AMENDMENTS TO THE DRAWINGS

Title: Communications Spooler for a Mobile Robot
Inventors: Pack et al.
Atty Docket No. IRO-009
U.S.S.N. 10/811,316
Atty: CWStamos/ALJagenow
Annotated Sheet

FIG. 2

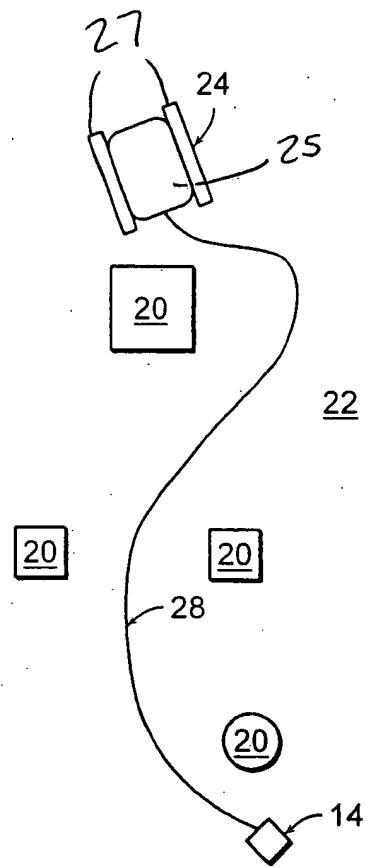
With this Amendment and Response, Applicants hereby amend FIGS. 2, 3A, 3B, and 12 to provide numerical designations for elements depicted in the figures. Applicants hereby amend paragraph [0003] to correct a typographical error. Applicants also hereby amend paragraphs [0017], [0019]-[0021], and [0052] to more clearly describe elements depicted in the drawings and disclosed in the specification. No new matter is added thereby. Support for the amendments can be found in the specification and figures as filed.

that all features are shown in the drawings as filed. Nonetheless, Applicants amend the drawings to more clearly identify the claimed elements. Applicants also hereby amend the specification to more clearly describe the elements shown in the drawings and disclosed in the specification. Moreover, Applicants hereby amend claims 11¹, 20, and 25 to recite language consistent with that used in the specification. Specifically, Applicants amend claim 11 to recite, *inter alia*, “a substantially zero tension cable velocity based at least in part on platform velocity and on a position of the outlet with respect to a point around which the mobile platform turns.” Claim 20 has been amended to recite, *inter alia*, “a cable comprising a stowed portion and an end portion.” Claim 25 has been amended to recite, *inter alia*, “a substantially zero tension cable velocity based at least in part on platform velocity and on a position of a cable outlet from the mobile platform with respect to a point around which the mobile platform turns.” Accordingly, Applicants respectfully submit that the objection to the drawings has been overcome.

Applicant submits herewith four drawing sheets marked "Replacement Sheet," which incorporate amendments made to FIGS. 2, 3A, 3B, and 12. Applicant also submits four drawing sheets marked "Annotated Sheet," with amendments made to the drawings indicated in red thereon. In accordance with 37 C.F.R. § 121(d), amendments to the drawing are explained in the Remarks section of this paper.
